REMARKS

AMENDMENTS TO THE DRAWINGS

APPENDIX A
Replacement Drawing Sheets

FIG. 3

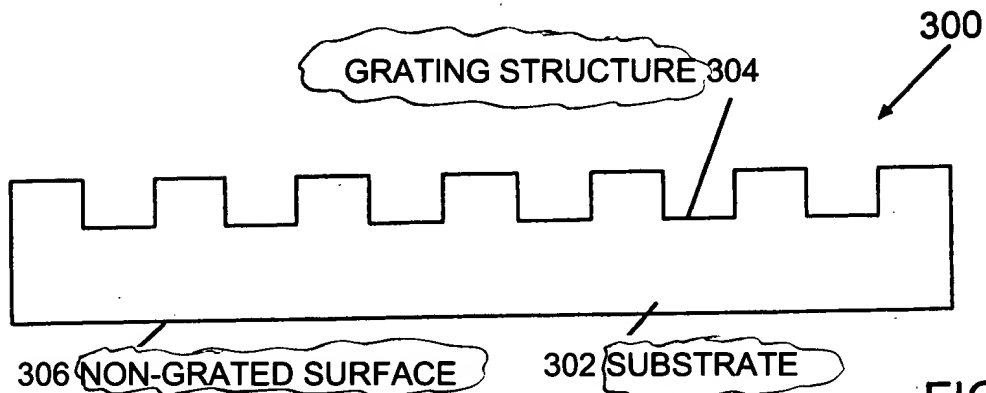
FIG. 3 was further objected to on the grounds that reference numbers 302 and 306 are duplicate reference numbers for the same item. The objection should be withdrawn inasmuch as 302 refers to a substrate, and 306 refers to a non-grated surface of the substrate 302.

- The second sheet which contains FIGS. 3-5 replaces the original sheet that contains FIGS. 3-5. FIGS. 3-5 have been changed as required by the examiner.

FIG. 6

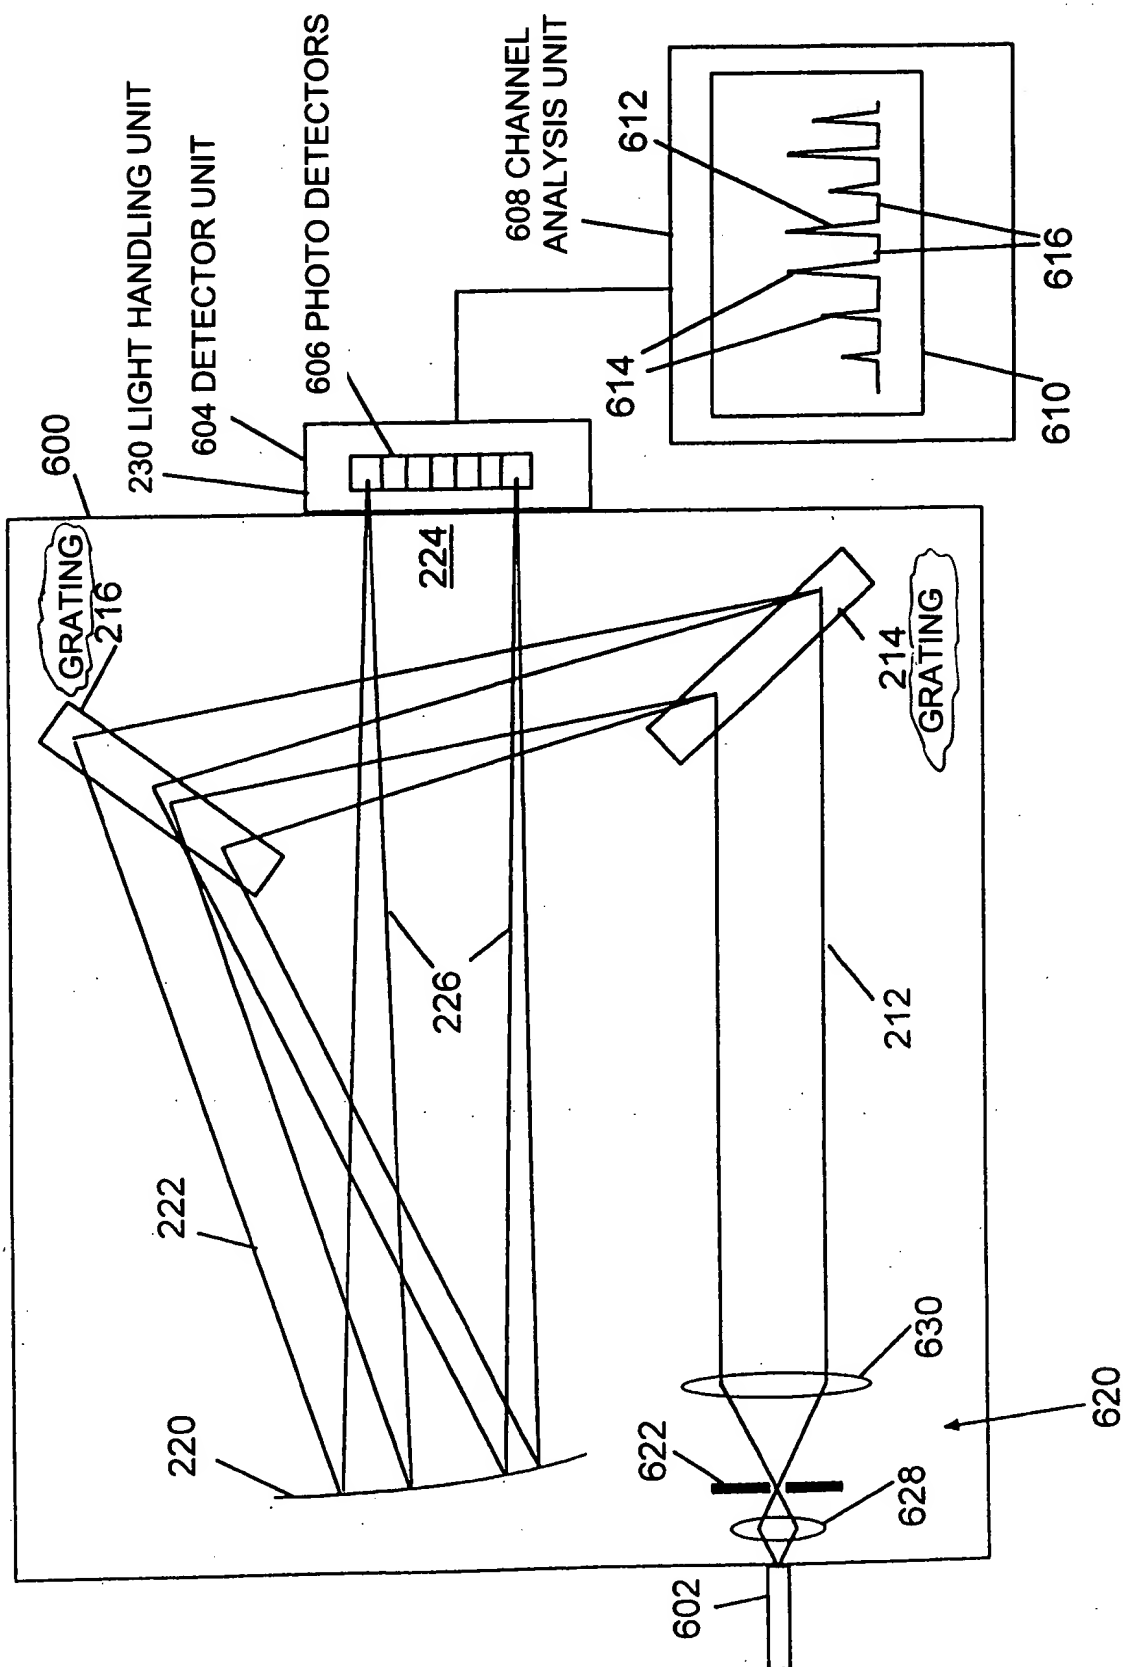
- The third sheet which contains FIG. 6 replaces the prior replacement sheet that contains FIG. 6. FIG. 6 has been changed as required by the examiner.

8
G.
F

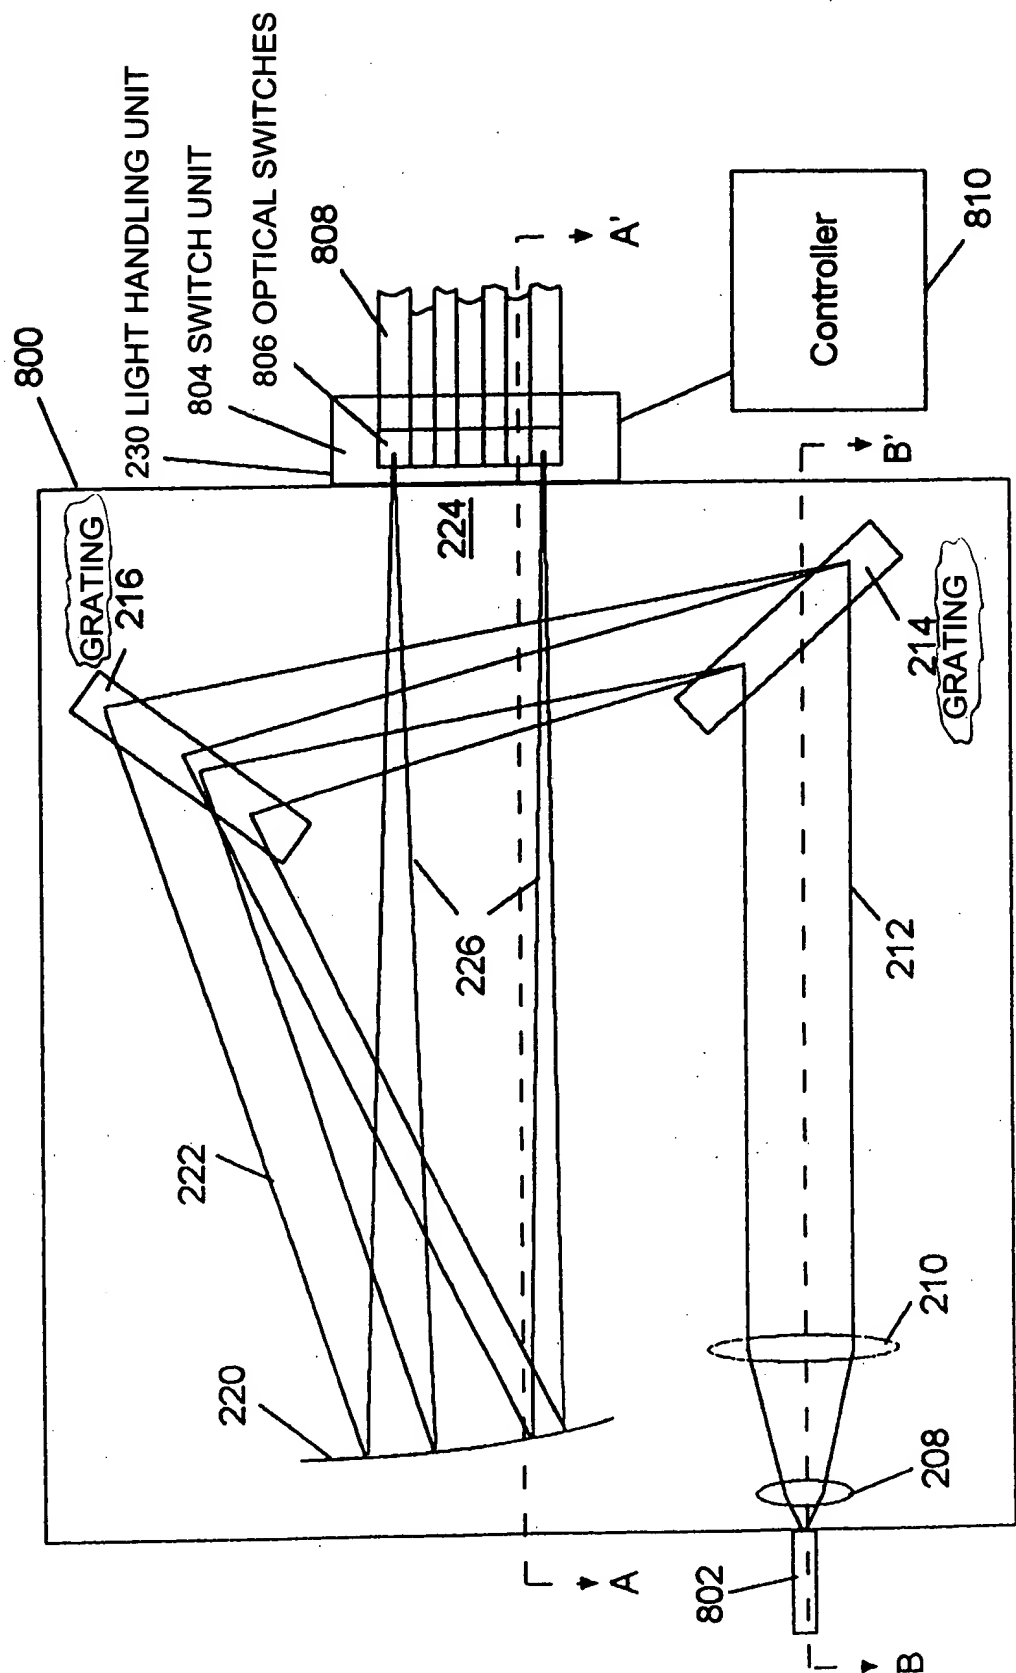
- The fourth sheet which contains FIG. 8 replaces the prior replacement sheet that contains FIG. 8. FIG. 8 has been changed as required by the examiner.

FIG. 20

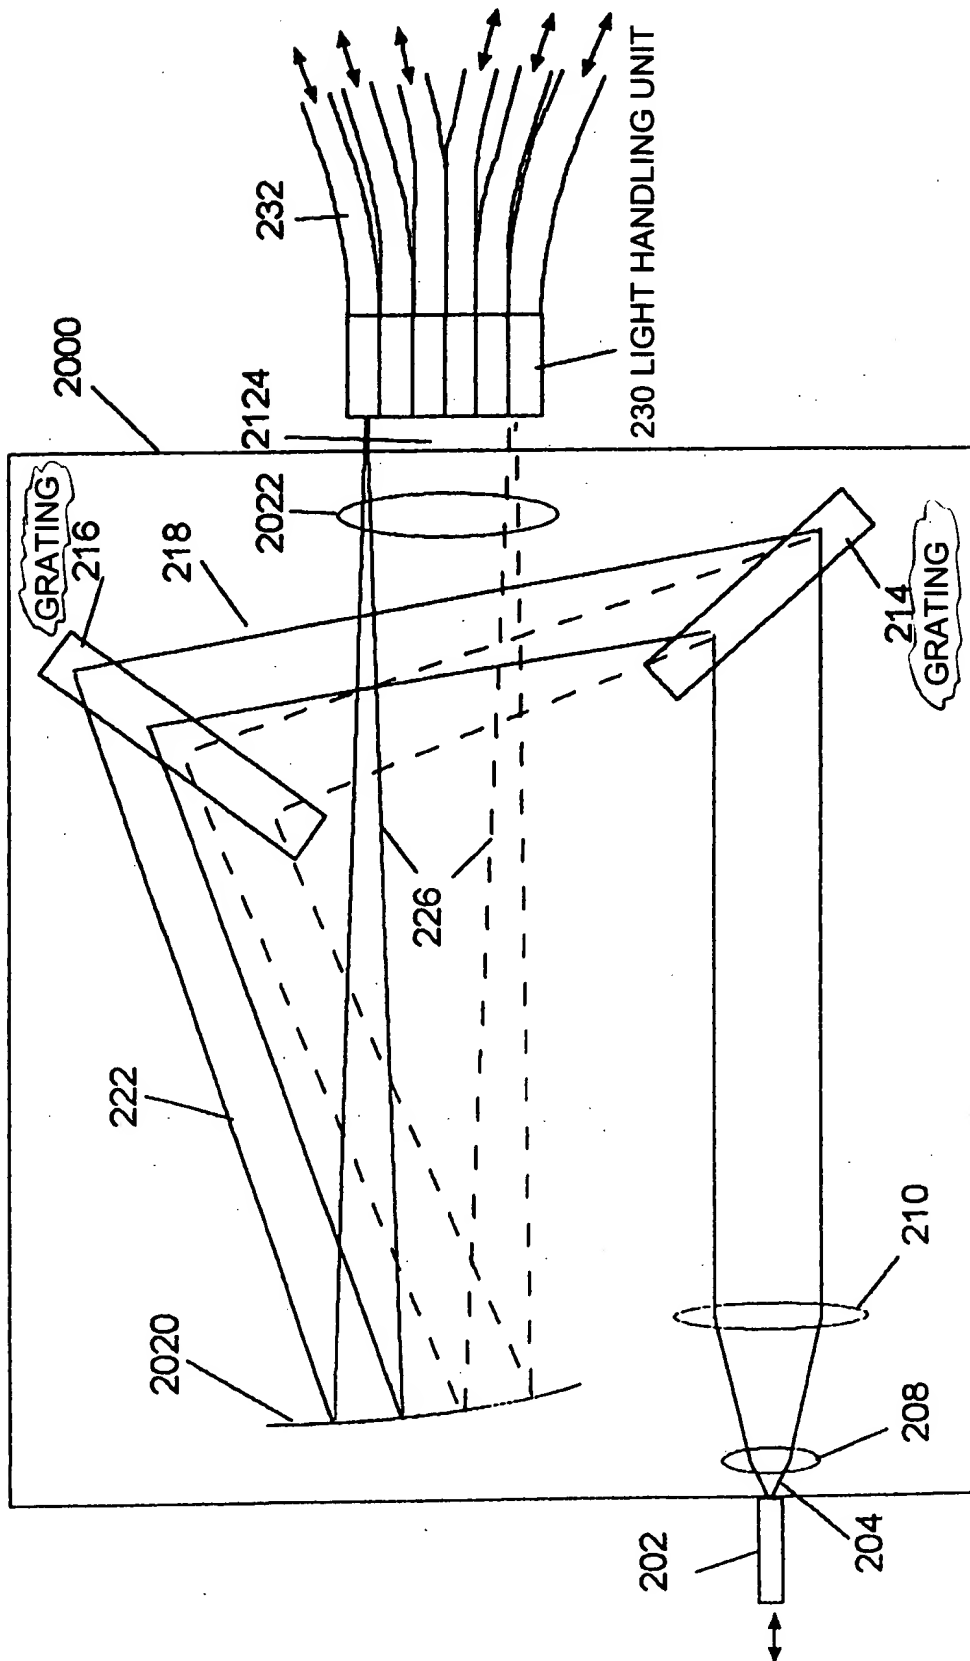
- The fifth sheet which contains FIG. 20 replaces the prior replacement sheet that contains FIG. 20. FIG. 20 has been changed as required by the examiner.

FIG. 21

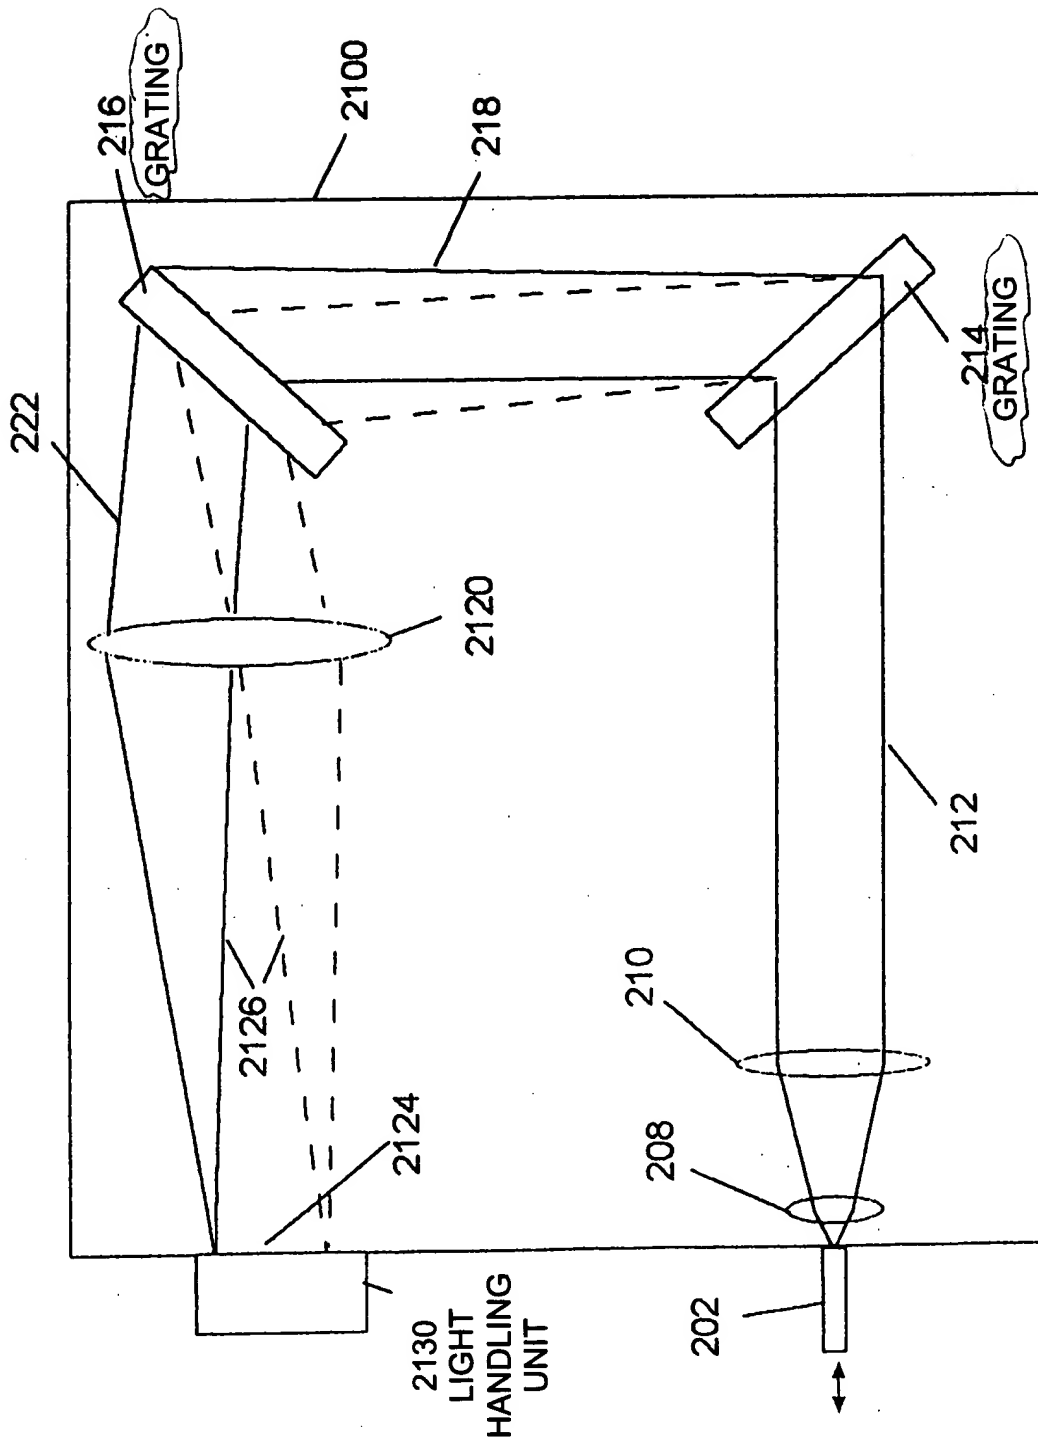
- The sixth sheet which contains FIG. 21 replaces the prior replacement sheet that contains FIG. 21. FIG. 21 has been changed as required by the examiner.

FIG. 29

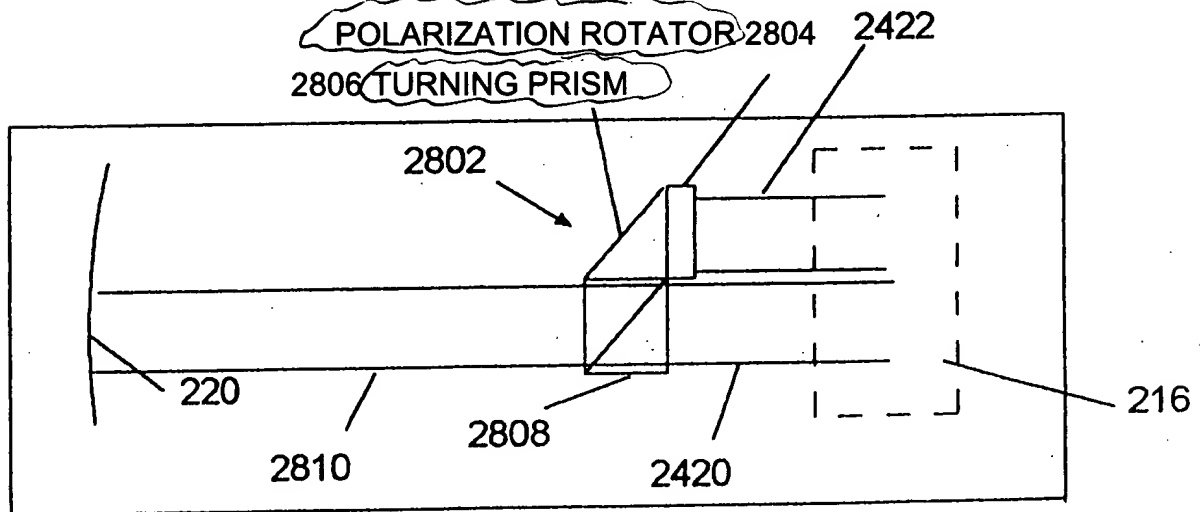
- The seventh sheet which contains FIGS. 22 and 29 replaces the prior replacement sheet that contains FIGS. 22 and 29. FIG. 29 has been changed as required by the examiner.

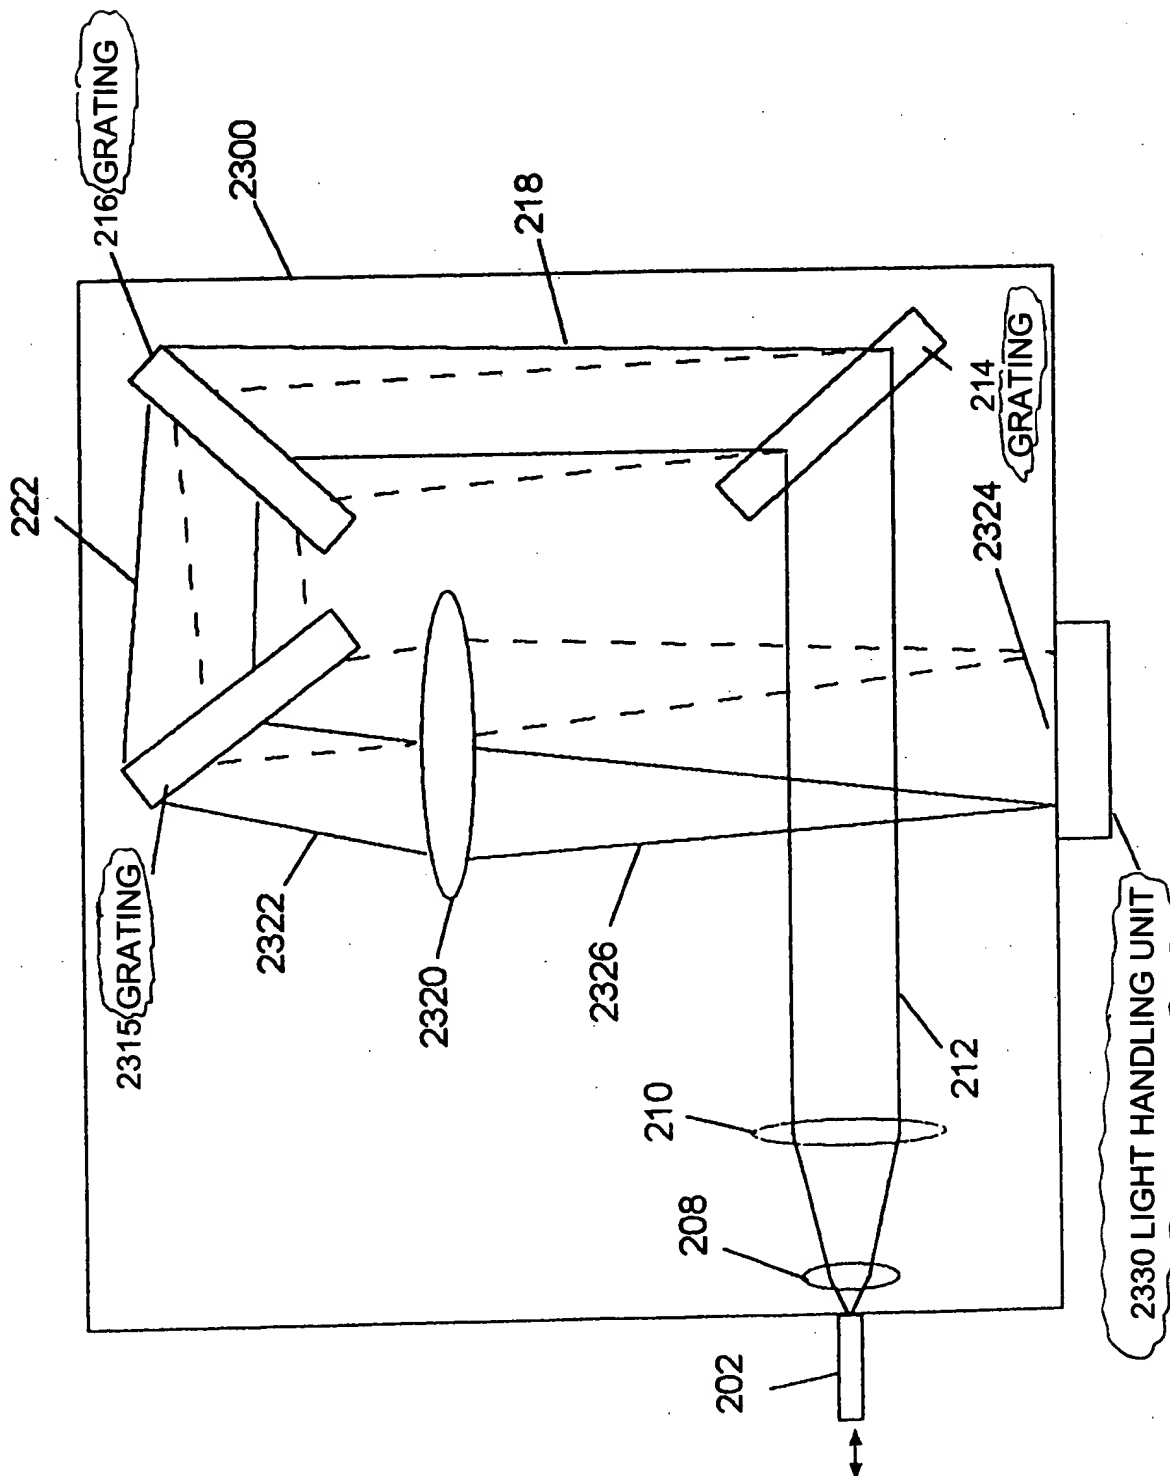
- The eighth sheet which contains FIG. 23 replaces the prior replacement sheet that contains FIG. 23. FIG. 23 has been changed as required by the examiner. In addition, the label for reference number 2330 has been repositioned.
